Subject: Final Rule, Response to Petitions for Reconsideration, Technical Amendment, Docket No. 2008-0111, Anthropomorphic Test Devices; ES-2re Side Impact Crash Test Dummy 50th Percentile Adult Male.

First Technology Safety Systems (FTSS) has reviewed the February, 2008, ES-2re dummy drawing package (identified in the above mentioned technical amendment) and we have identified a number of drawing errors and a number of drawing issues. We seek to petition NHTSA to correct these drawings to ensure that the ES-2re dummy continues to meet the same dimensional and performance requirements established for the dummy when the dummy was proposed for inclusion into 49 CFR Part 572 Subpart U. FTSS makes the following comments and recommendations with respect to the drawing package. A marked up drawing for each of these recommended changes are attached to the end of this letter.

ITEM NO.	QTY	PART NO.	DESCRIPTION
PART LIST			
UNITS ARE millimeters			NATIONAL HIGHWAY TRAFFIC SAFETY ADMINISTRATION
MATERIAL REF. 080M40 STEEL (EN8)			
SCALE 1.000			FEMUR BEARING PLATE, RIGHT
APPROVALS			
DATE			DRAWING NUMBER 175-6068
DRAWN			
CHECKED			REV. B
ENGINEER			
SIZE A2		SHEET 1 OF 1

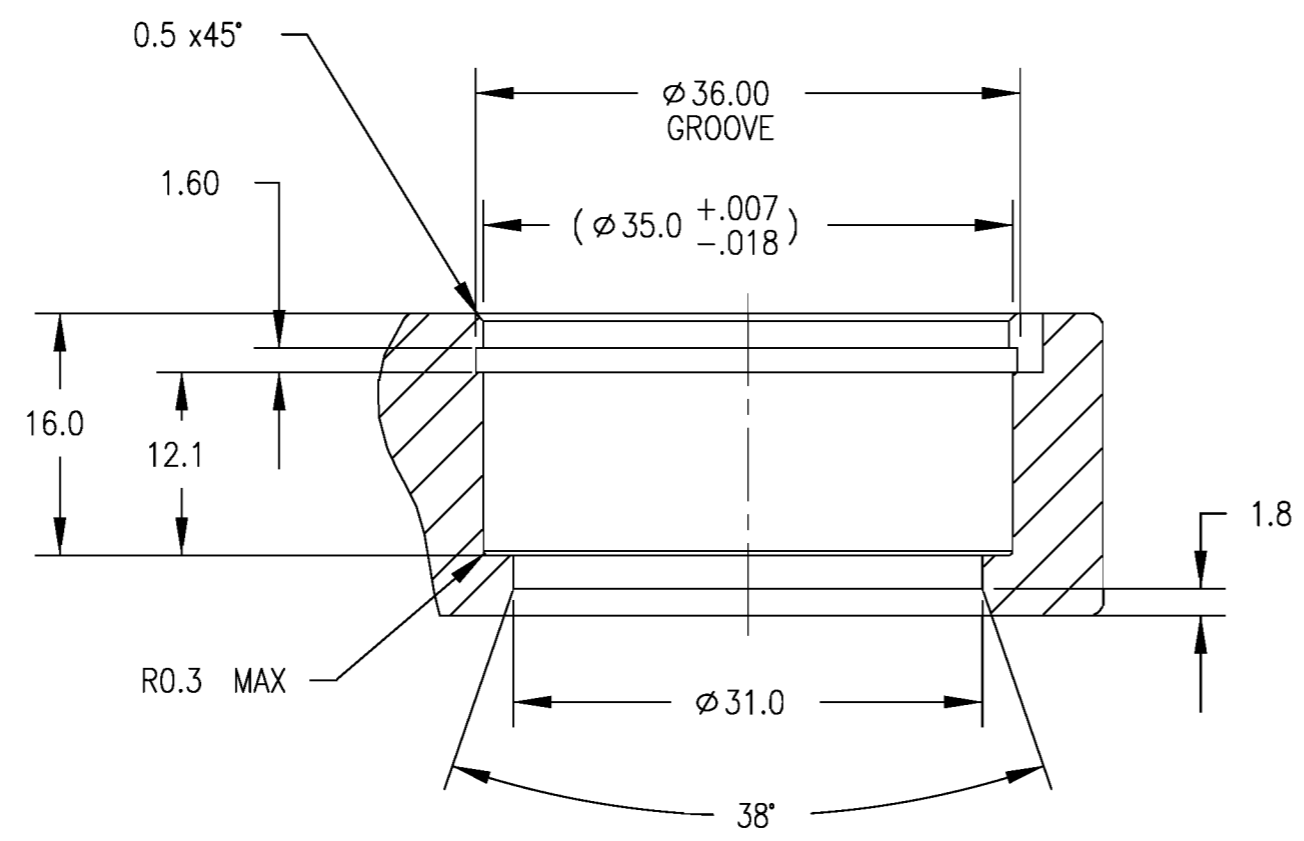
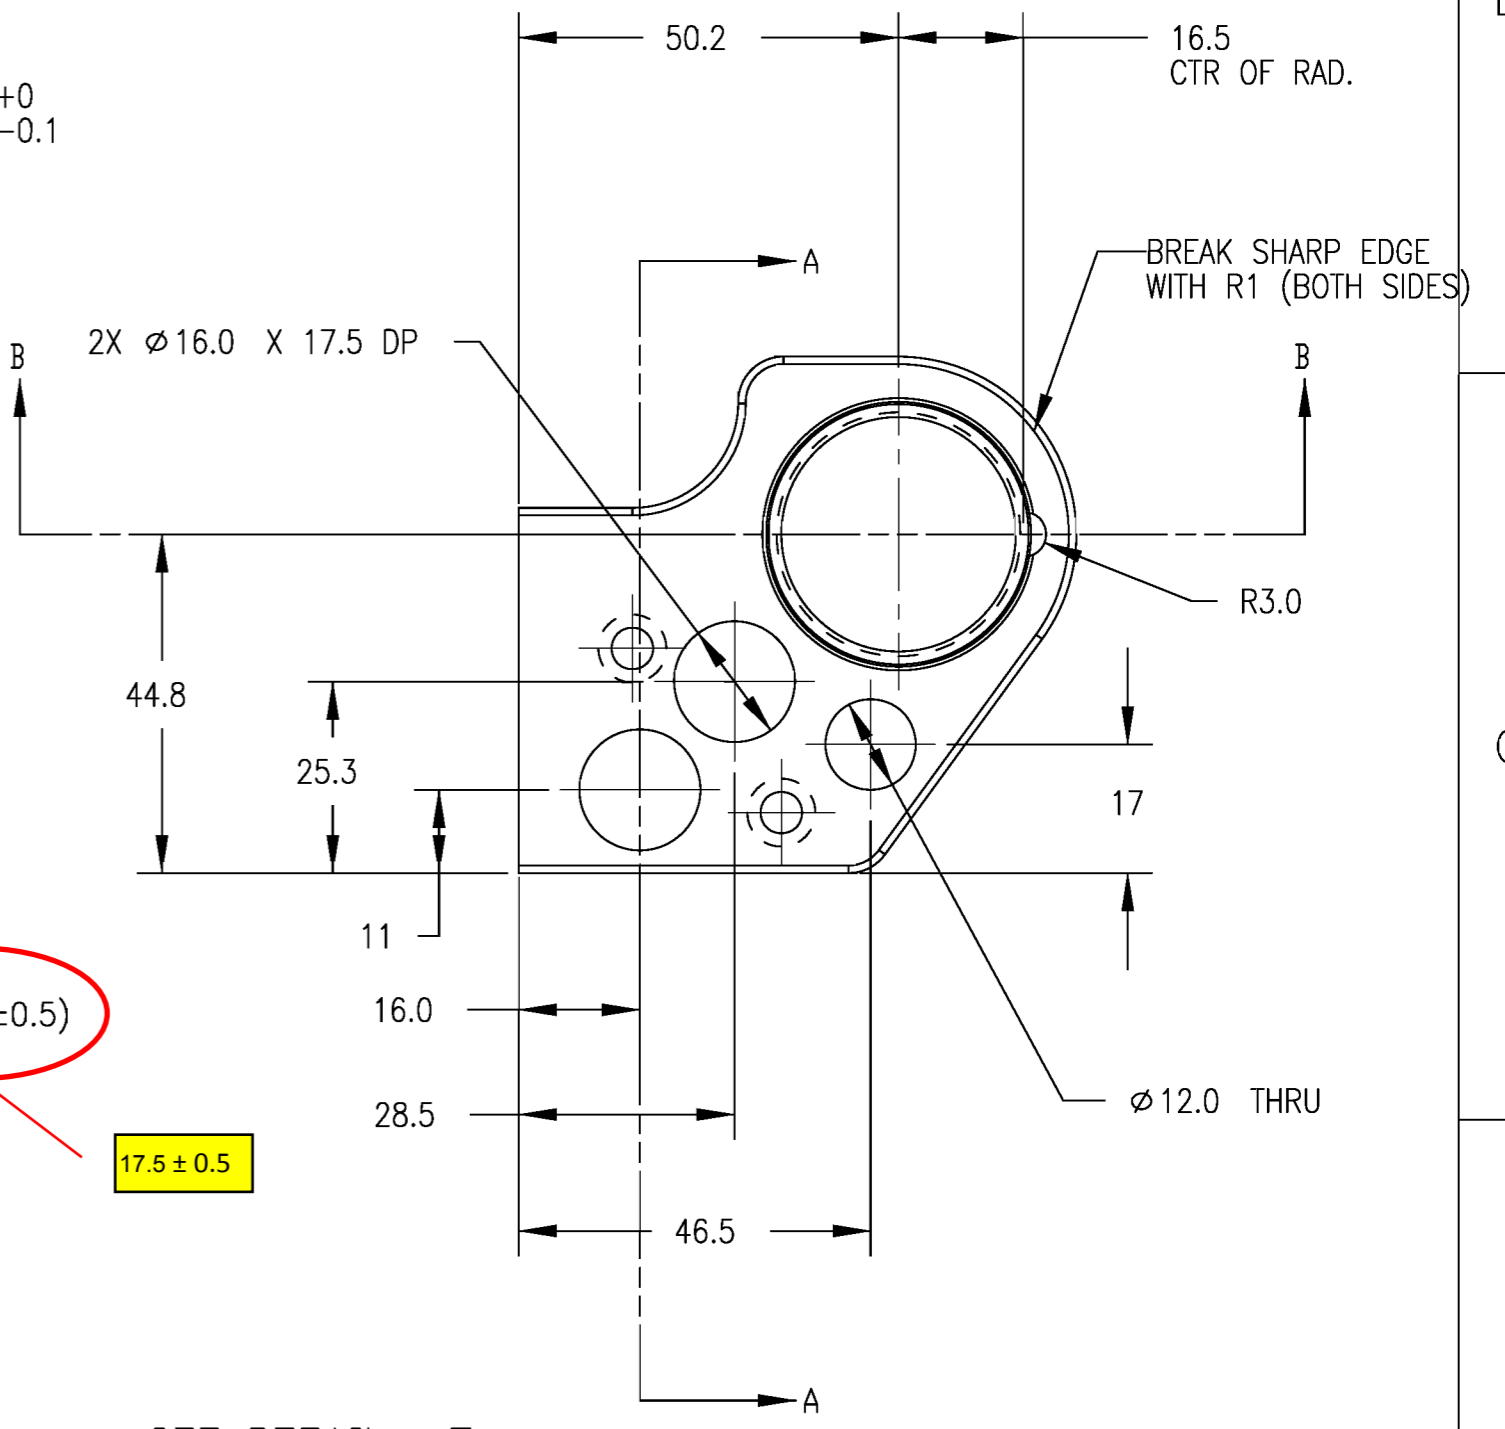
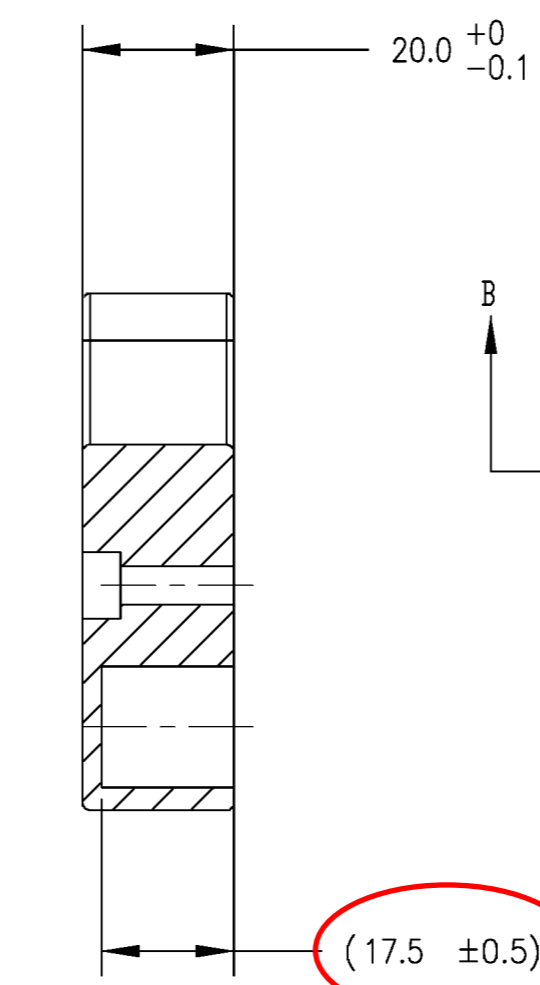
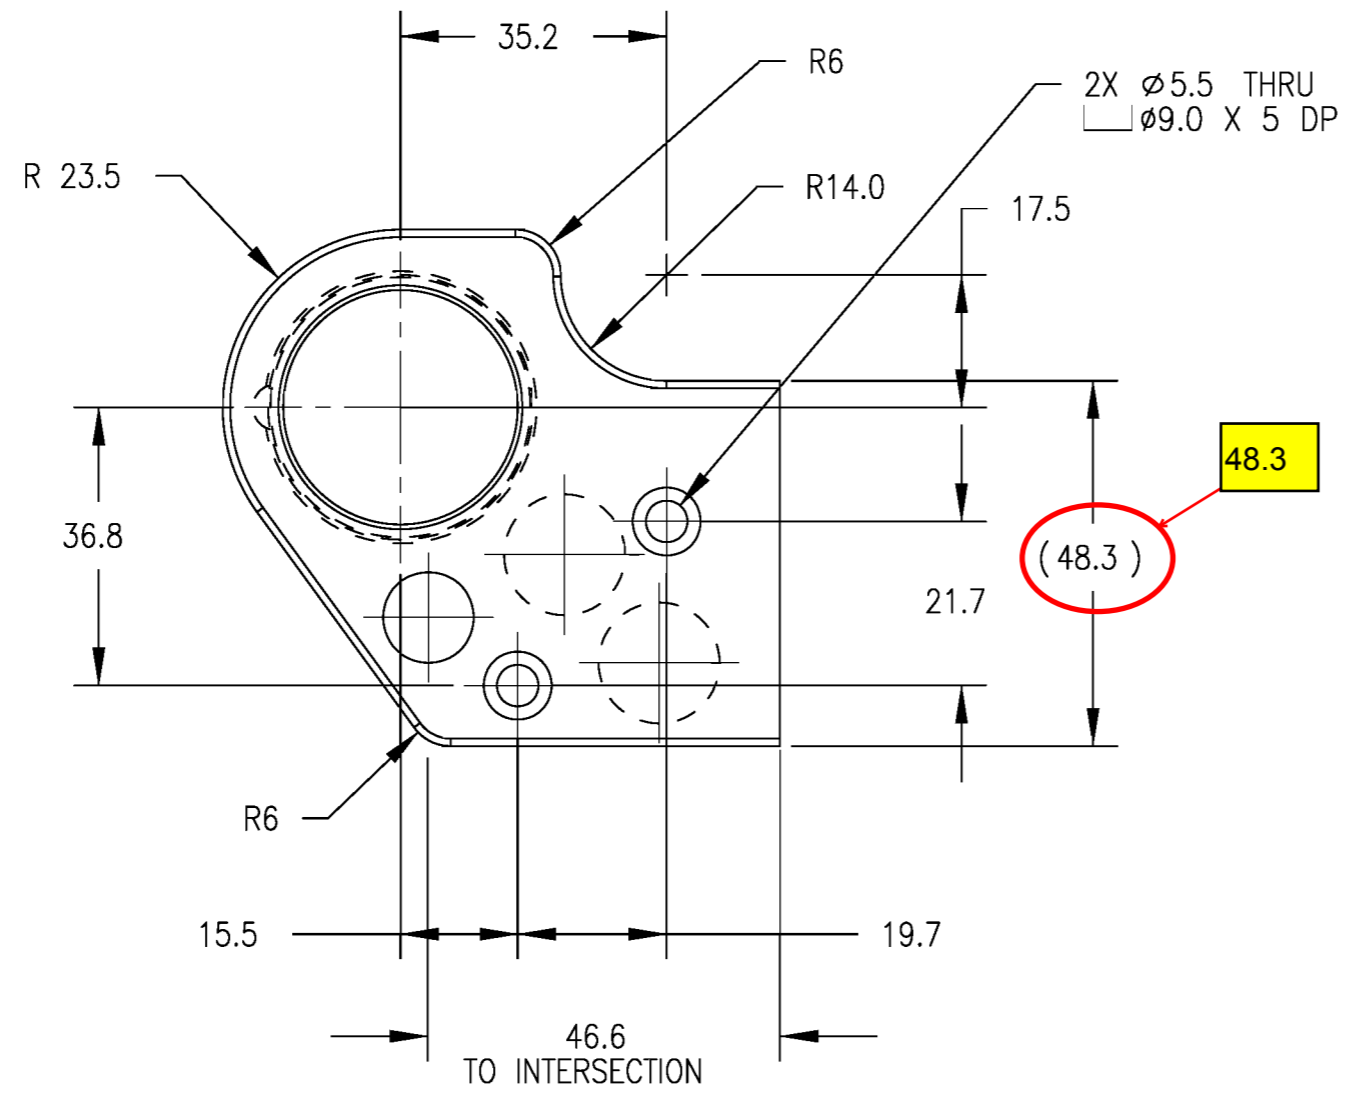
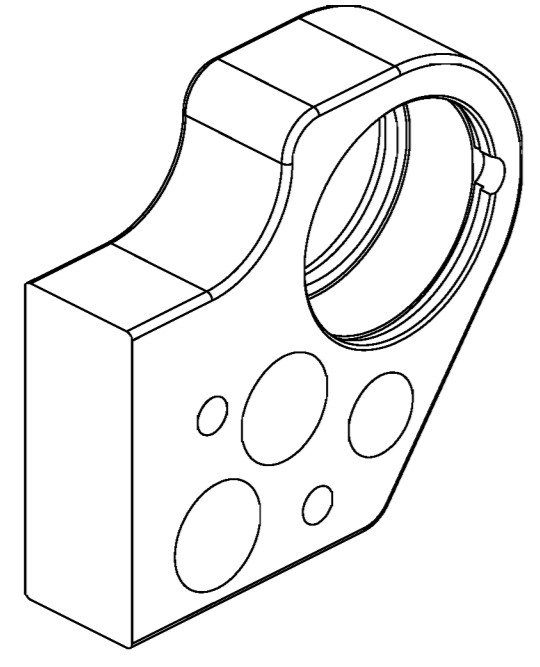
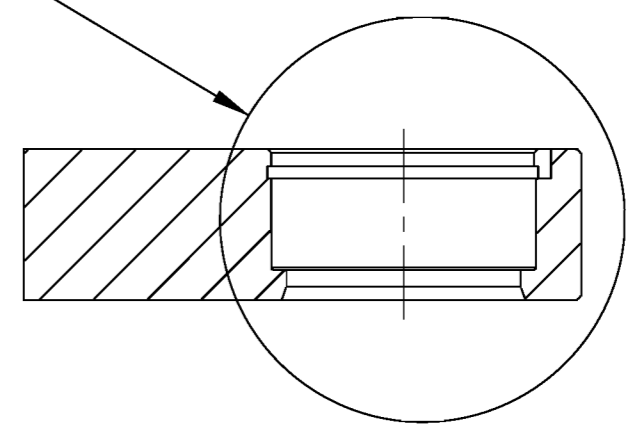
- 7) Drawing 175-6068, Femur Bearing Plate, Right. Fix typographical errors by removing the parenthesis from around dimensions (48.3) " and (17.5 ± 0.5) ". This will maintain consistency between NHTSA Drawings 175-6068 and 175-6063.
